TO : All Bidders  
FROM : George M. Wiens  
PROJECT : CTE Classroom Addition  
Vista Murrieta High School  
1615400.41  
SUBJECT : Addendum 4  
DSA : 04-115755 / 33-H18

CTE Classroom Addition

Addenda No. 4 – Scope Questions / Clarifications

DRAWING NUMBER: **E5.2**

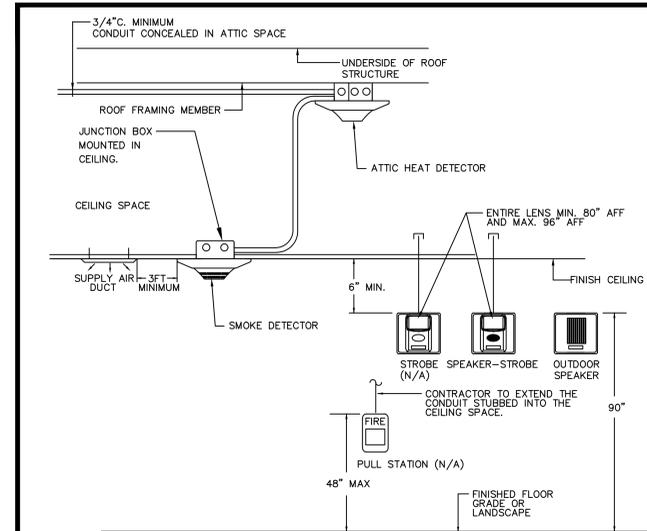
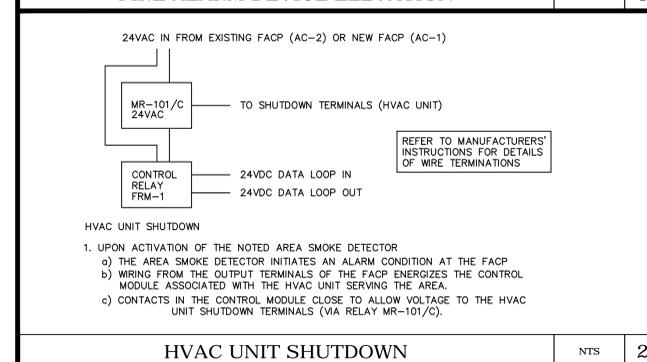
A. Revise as indicated in the clouded area labeled Delta 4 on the attached E5.2.
